Parts Bulletin

Group	Number	Version
P-97-4	18	02

QL Bow Thrusters Program Update

Models: QL Accessories

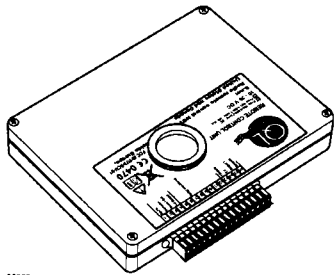
The current control unit PIN 41100658 for the BP series as spare part for products listed below are updated with a new version.

The new control unit features new safety functions as well as the possibility to upgrade to wireless remote control operation.

New PIN	Market	
21281780	EUIESS	CE 0470
21313484	US/Canada	FCC-approved

Important: reason for two new PIN's are that the control unit's are pre loaded with radio receiver for wireless remote control. Please check what *radio directives* apply for your market before installation of wireless remote control.

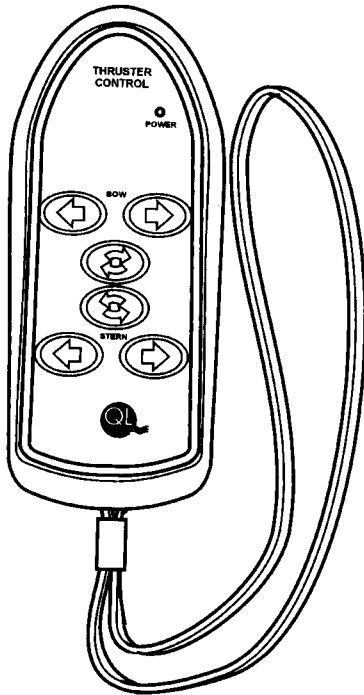
For wireless remote control operation a remote control is needed that needs to be ordered separately.

PIN	Market	
41100887	EUIESS	CE 0470
41100888	US/Canada	FCC-approved

Note the remote control unit and the control unit must have a market match for proper operation. For more information please look in publication 774827402.2009.
